# RAILROAD COMMISSION OF TEXAS

## SURFACE MINING AND RECLAMATION DIVISION

RE: Monticello-Thermo Mine, Permit No. 5G  
Revision No. 34  
H-Area Reclamation Plan

**Monticello-Thermo Mine, Permit No. 5G**  
**Revision No. 34**  
**Proposed H-Area Reclamation Plan**  
**Concerns Rendering the Application ~~Incomplete~~ or Deficient**  
**September 21, 2018 (originally noted on January 19, 2018)**

# ATTACHMENT B

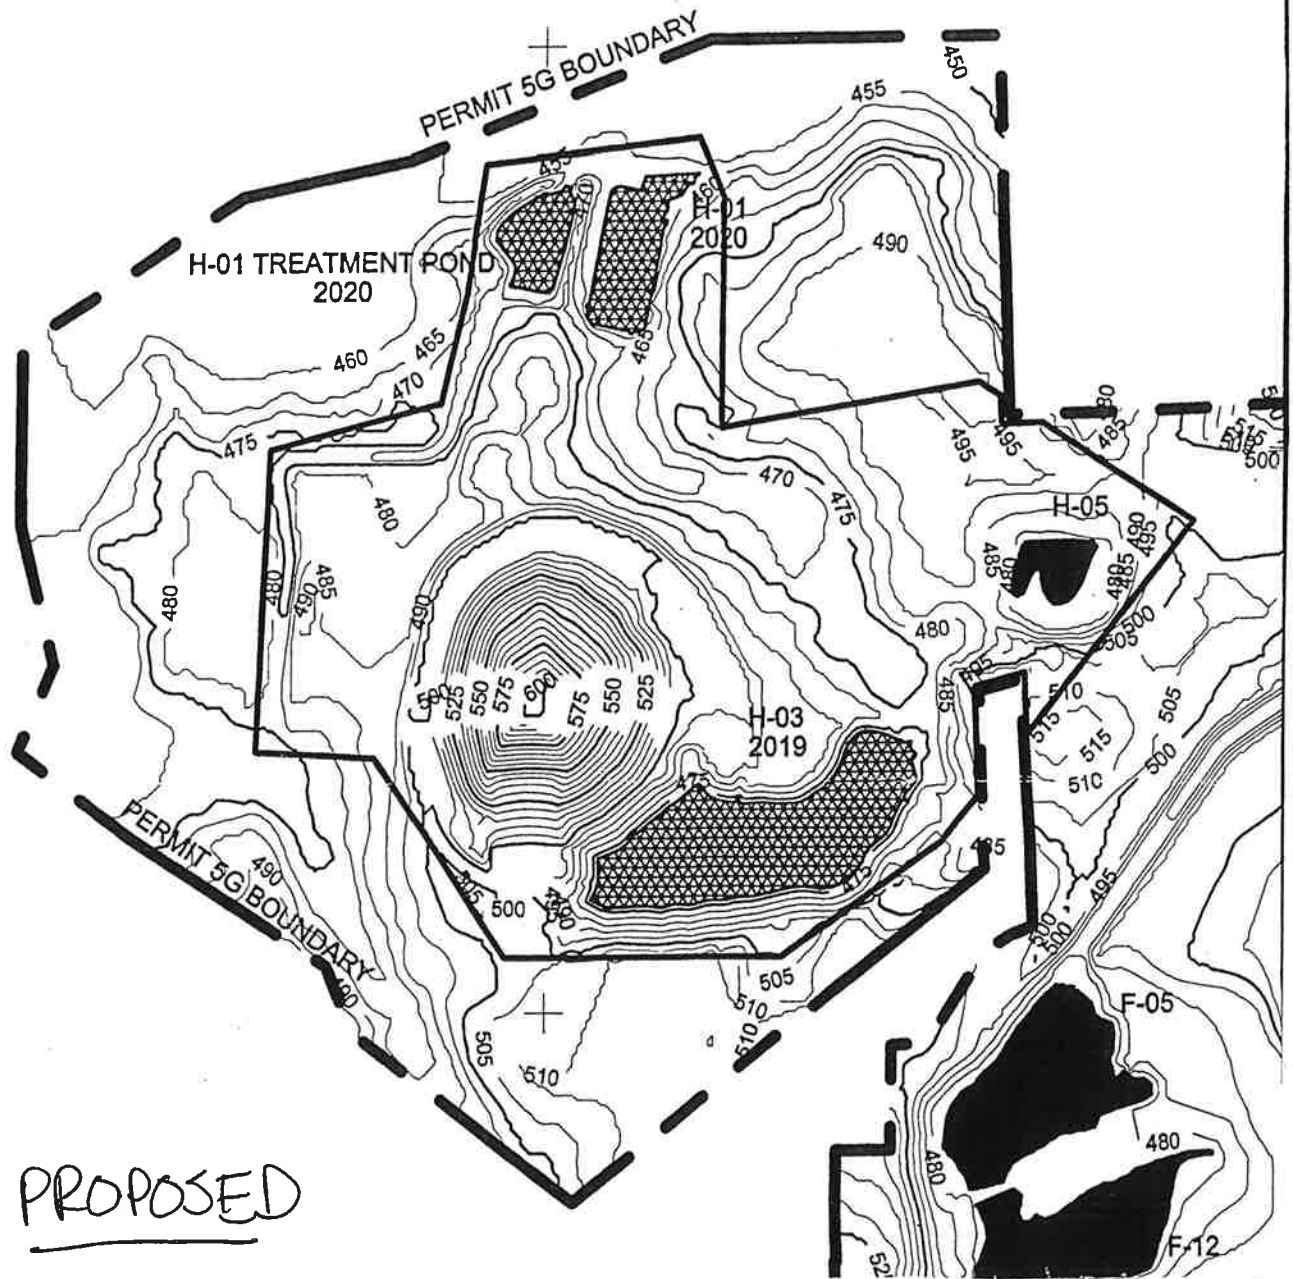
Revision 34 primarily seeks to change (increase) post mine slopes for 75 acres in the H area from what was approved in Revision 30. Attachment A is a figure showing currently approved slopes in the H area; attachment B shows the proposed slopes. Two key elements of the revision application include leaving an unsuitable material stockpile in place and covering it with four feet of topsoil to build a hill, rather than using the stockpile to fill in the final mine pit, and leaving the final mine pit in its current configuration as a water body instead of filling it in and sloping is as shown in Attachment A.

FIGURE 1: AERIAL IMAGE OF H-03 POND AND SURROUNDING AREA (THERMO MINE)

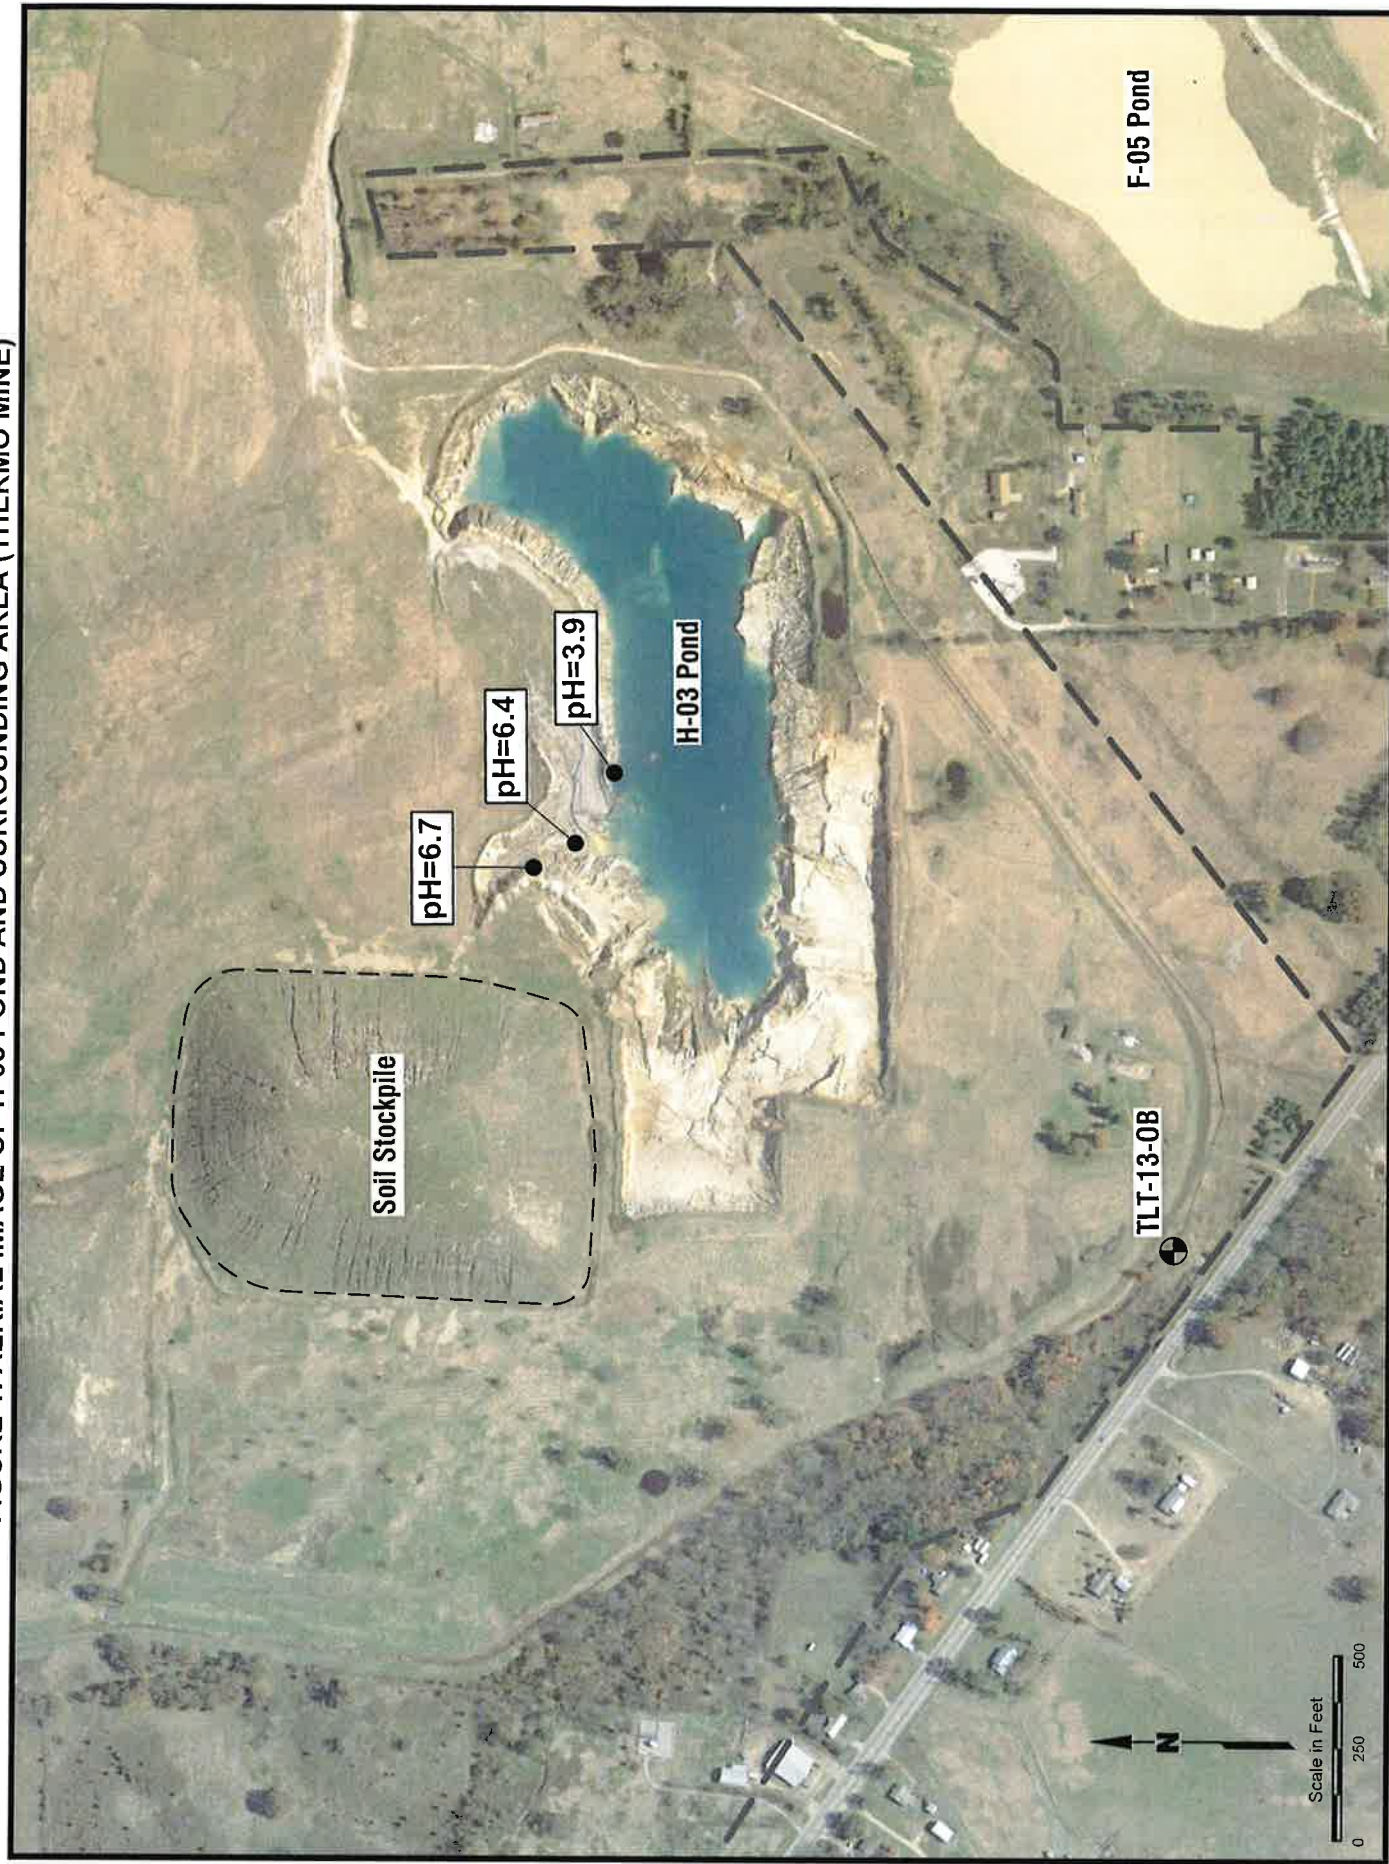
During the site visit, I was accompanied by Luminant employees from the Monticello Mine (Mr. Monty Ward and Mr. Bill Mason). An aerial photograph showing the locations of the H-03 Pond and nearby soil stockpile is provided as Figure 1. Photographs taken during the site visit are provided in Attachment A.

A pH measurement of 3.9 was taken from the pond at the approximate location shown on Figure 1. According to Luminant personnel, previous pH measurements from the pond had ranged from about 3.9 to 5.5, with the higher pH values coinciding with higher pond levels. The pond level was relatively low during the site visit.

Groundwater seeps were observed emanating from some erosional features along the northwestern slopes adjacent to the pond. The seep origin was about halfway up the unreclaimed slopes. No seepage was observed coming from the southeastern corner of the soil stockpile. Seep photos are provided in Attachment A. Two seep pH measurements were taken at the approximate locations shown on Figure 1. A pH of 6.4 was measured in the seepage closest to the pond. Closer to the seep source, the seepage had a pH of 6.7. We were not able to walk the entire perimeter of the pond due to access issues, so other similar seeps may exist. Luminant personnel had driven the entire perimeter of the soil stockpile the previous day and not observed any seeps emanating from its base.

The closest overburden baseline groundwater well to the H-03 Pond is TLT-13-OB (see Figure 1). As reported in Section 128 of the Thermo Mine Permit, the water table was encountered less than five feet below ground surface when measured during the baseline period in 2005 (Table 128-4). The groundwater elevations ranged from an elevation of about 490 to 492 feet above mean sea level. Table 128-5 in Section 128 shows that the pH of TLT-13-OB ranged from about 6.7 to 7.1, indicating that the shallow overburden groundwater system has a neutral pH.

It is my understanding that Luminant will cover the exposed lignitic material with four feet of suitable material in accordance with the approved reclamation plan. I also understand that Luminant typically uses suitable material to cover the sides of the pit at least 10 feet below the normal pool level. Following these reclamation activities, it is likely the pH of the H-03 Pond will increase. Other ponds at the Thermo mine exhibit near-neutral pH conditions following reclamation activities.

Groundwater seepage flowing into H-03 Pond

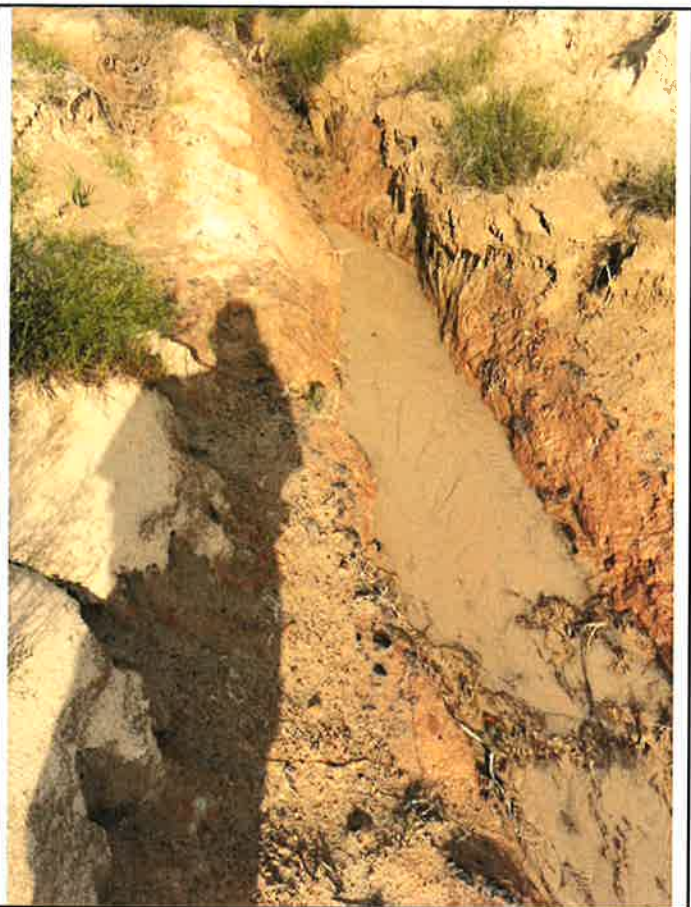
H-03 Pond. pH reading of 3.9 was taken near shoreline.

FIGURE E-1  
THERMO MINE  
H-AREA RECLAMATION PLAN  
LUMINANT MINING COMPANY LLC

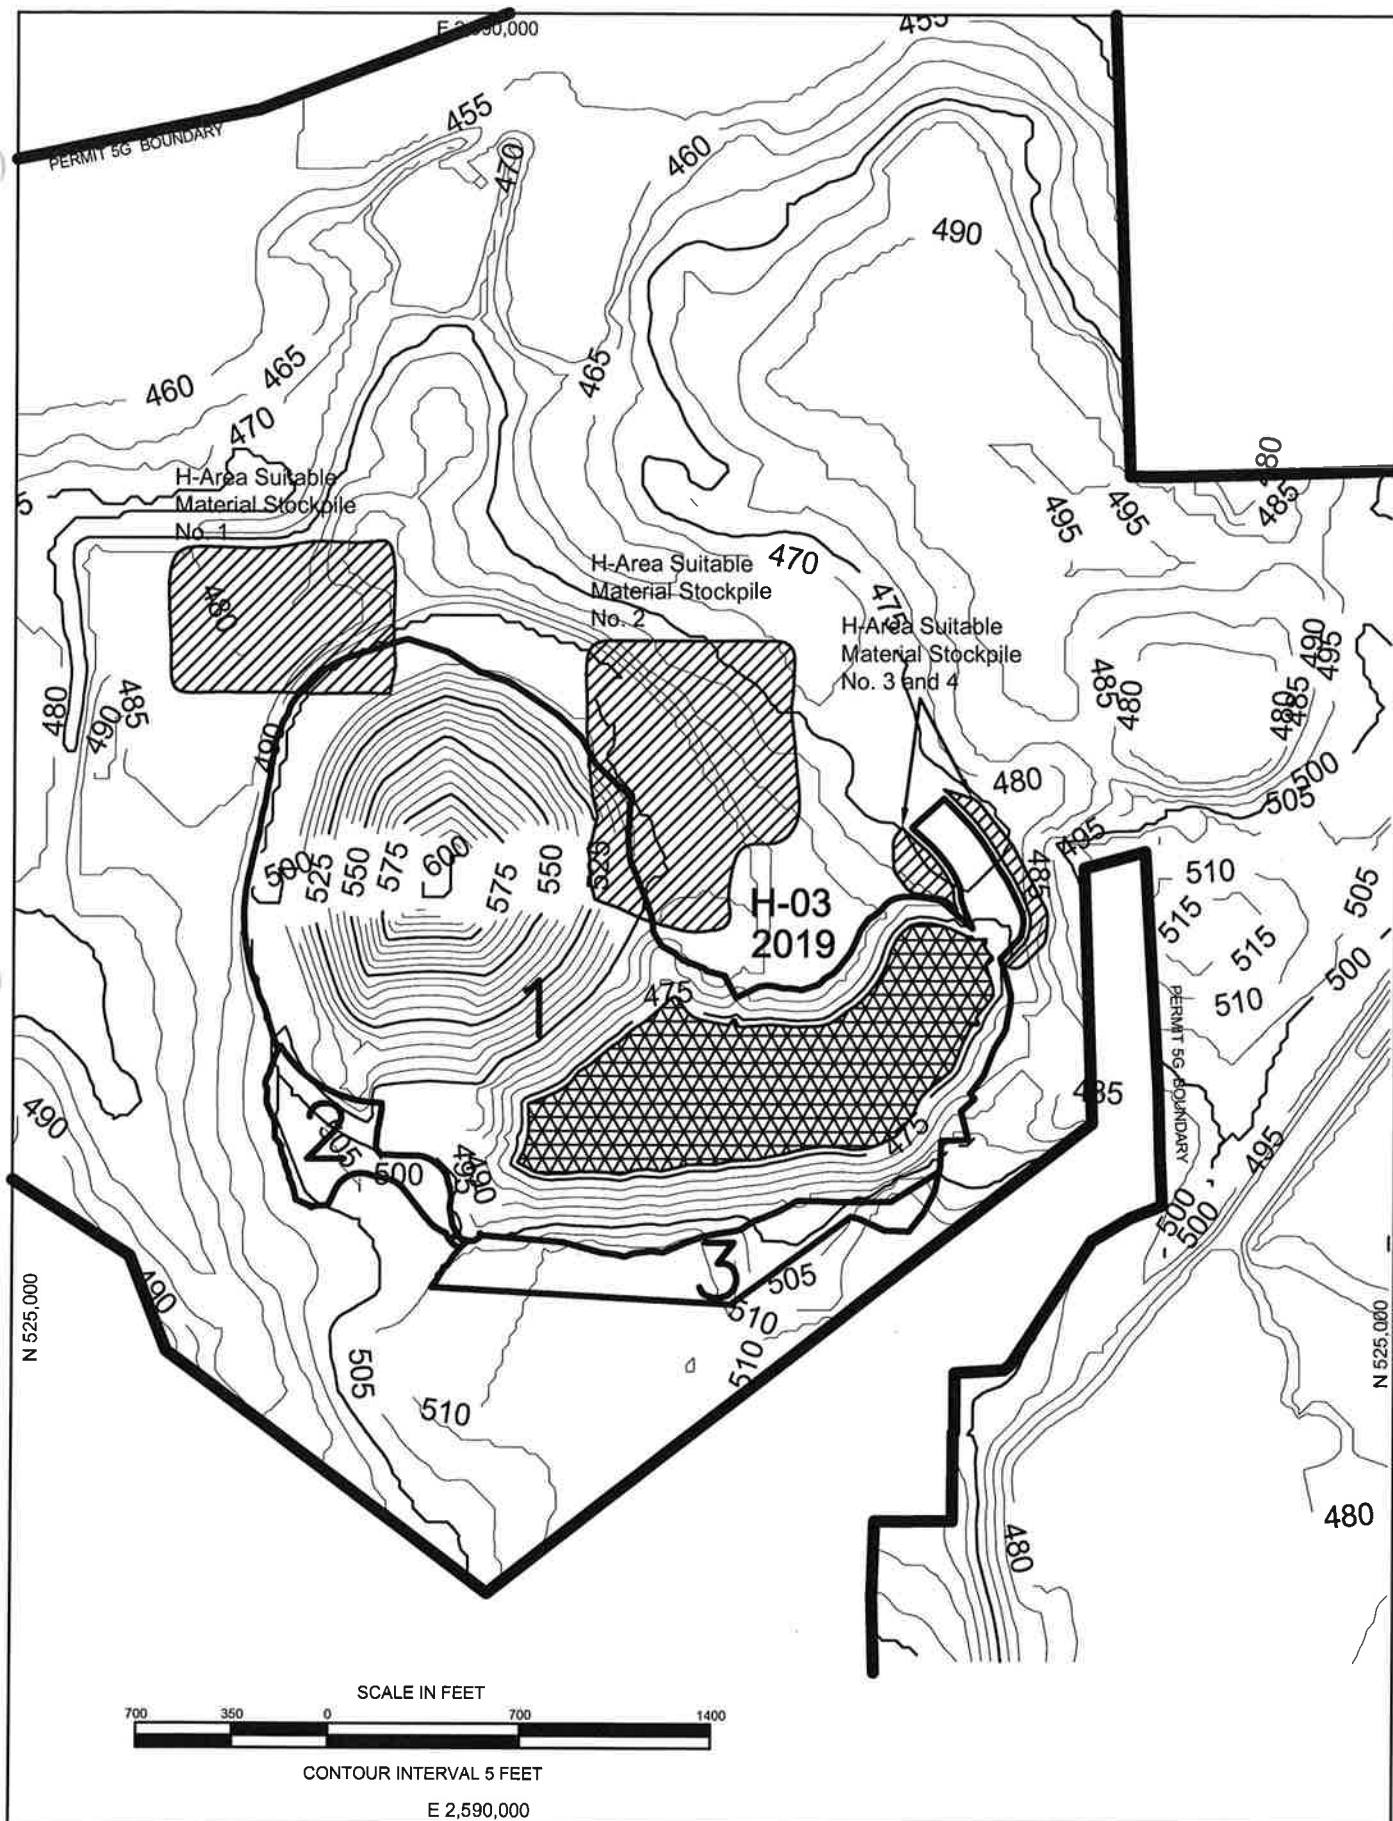
- B-12. §12.139 Luminant classifies the material that will remain in Zone 2 and in Zone 3 as “*Suitable Material*” in an affected area that was not mined during progression of the active pit. Luminant provided no details regarding the potential ripping and diking of Zone 2 and Zone 3 following suitable material removal, nor what it plans to do with the excess stockpile material. Staff considers that Luminant’s proposed ripping and diking plan must be no less intensive than that approved for the Oak Hill Mine, Permit No. 46C, Revision No. 40.

- B-13. §12.139 Information needs to be provided to clarify how Luminant determined the amount of recoverable suitable material in each zone and in each stockpile as listed in Table 139 E-2, including the depth of removal.

- B-14. §12.139 Luminant indicates in Appendix E that mobile equipment will move approximately 750,000 cubic yards of subgrade material from Zone 1; however, it is not clear where the material will be placed. Additionally, an explanation has not been provided to justify the proposed start date of the activities proposed in the reclamation plan.
